Application No. 09/925,675
Response to Office Action

Amendments to the Drawings:

FIG. 1
PRIOR ART

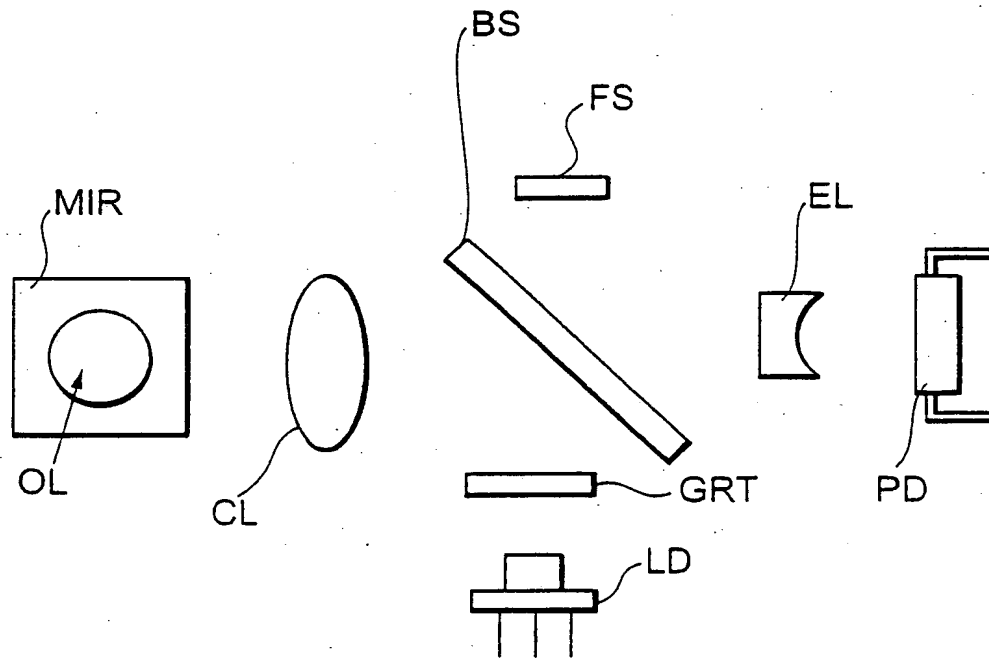
Figs. 1-5 have been amended to change RELATED TECHNIQUE to
PRIOR ART, as required by the Examiner.
